Well Name: PMS 8 FEDERAL	Well Location: T18S / R31E / SEC 8 / SWNE /	County or Parish/State: EDDY / NM
Well Number: 4	Type of Well: OTHER	Allottee or Tribe Name:
Lease Number: NMNM33437	Unit or CA Name:	Unit or CA Number:
US Well Number: 3001526218	Well Status: Producing Oil Well	Operator: MATADOR PRODUCTION COMPANY

Notice of Intent

Type of Action: Plug and Abandonment

PMS 8 Federal #004
1880' FNL & 1980' FEL Sec. 8-T185-R31E
Eddy County, NM / NMNM-33437
API: 30-015-26218
Planned P&A WELLBORE SCHEMATIC
Spudded: 10/27/1989

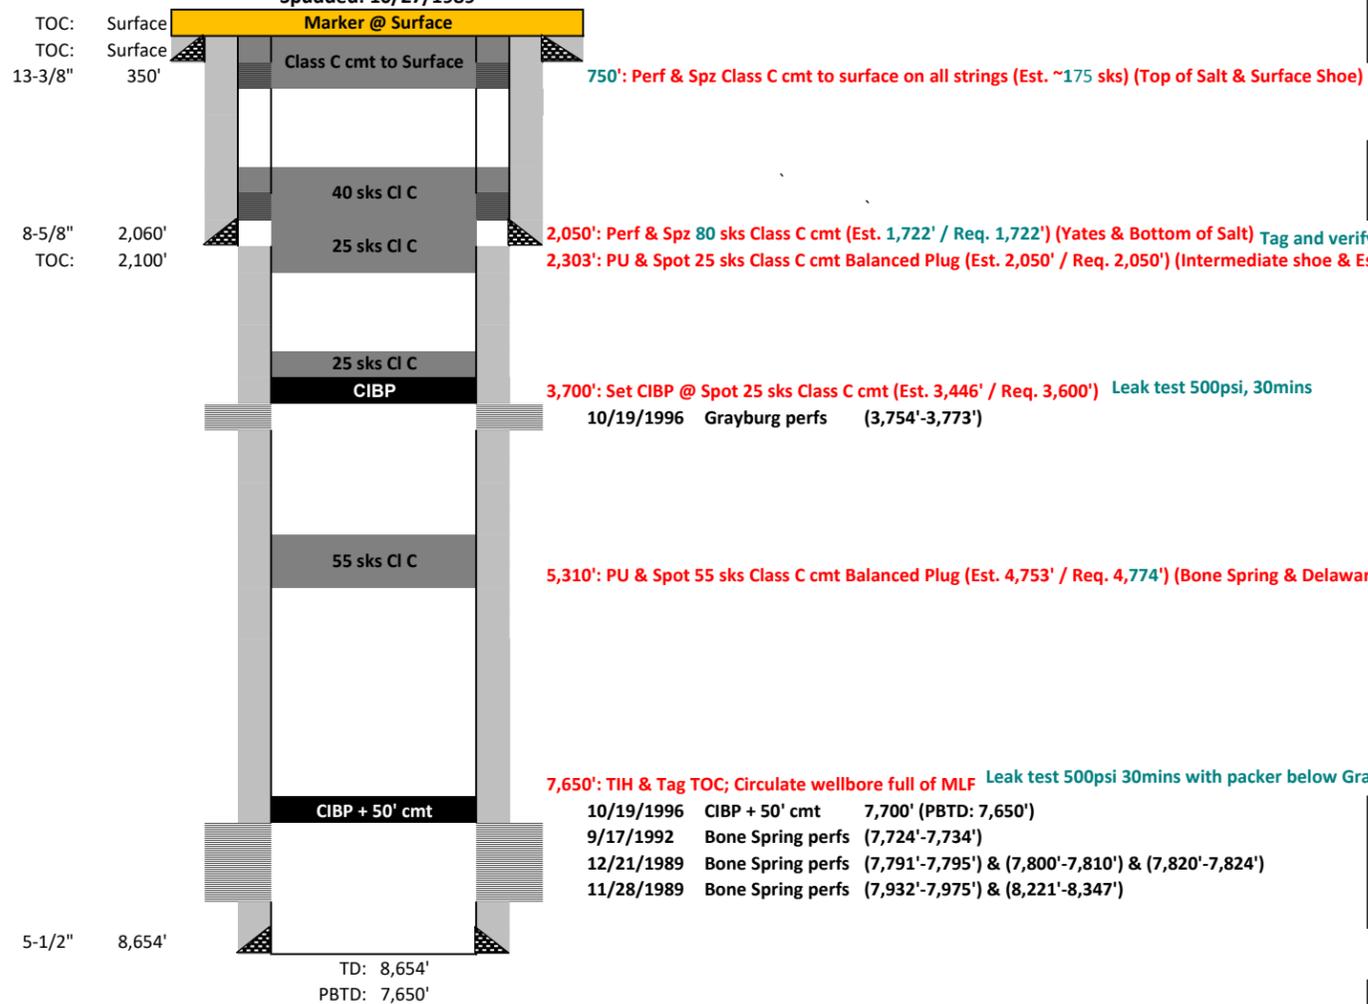
Plug Type	Top	Bottom	Length	Tag	Sacks	Notes
Surface Plug	0.00	100.00	100.00	Verify circulated to surface	30.00	Perf and sqz
Shoe Plug	296.50	400.00	103.50	WOC and Tag	30.00	Perf and sqz
Top of Salt @ 700	643.00	750.00	107.00	WOC and Tag	30.00	Perf and sqz
Base of Salt @ 1790	1722.10	1840.00	117.90	WOC and Tag	30.00	Perf and sqz
Yates @ 2002	1931.98	2052.00	120.02	WOC and Tag	45.00	Same as below plug
Shoe Plug	1989.40	2110.00	120.60	WOC and Tag	45.00	Perf and sqz.
TOC at 2100. Perf and sqz plugs above						
CIBP Plug	3665.00	3700.00	35.00	Verify depth	25.00	Leak test 500psi, 30mins
Delaware @ 4873	4774.27	4923.00	148.73		25.00	
Bonesprings @ 5260	5157.40	5310.00	152.60		25.00	
CIBP Plug	7665.00	7700.00	35.00	Verify depth		Already existing. Tag and verify. Pressure test well to 500psi, 30mins with packer below above perms

No more than 2000' is to be allowed between plugs in open hole, and no more than 3000' between plugs in cased hole.
Class H >7500'
Class C <7500'
Fluid used to mix the cement in R111P shall be saturated with the salts common to the section penetrated, and in suitable proportions, but not more than 3% calcium chloride by weight of cement will be considered the desired mixture whenever possible.
Critical, High Cave Karst: Cave Karst depth to surface
R111P: Solid plug in all annuli - 50' from bottom of salt to surface.

Onshore Order 2.III.G Drilling Abandonment Requirements: "All formations bearing usable-quality water, oil, gas, or geothermal resources, and/or a prospectively valuable deposit of minerals shall be protected.
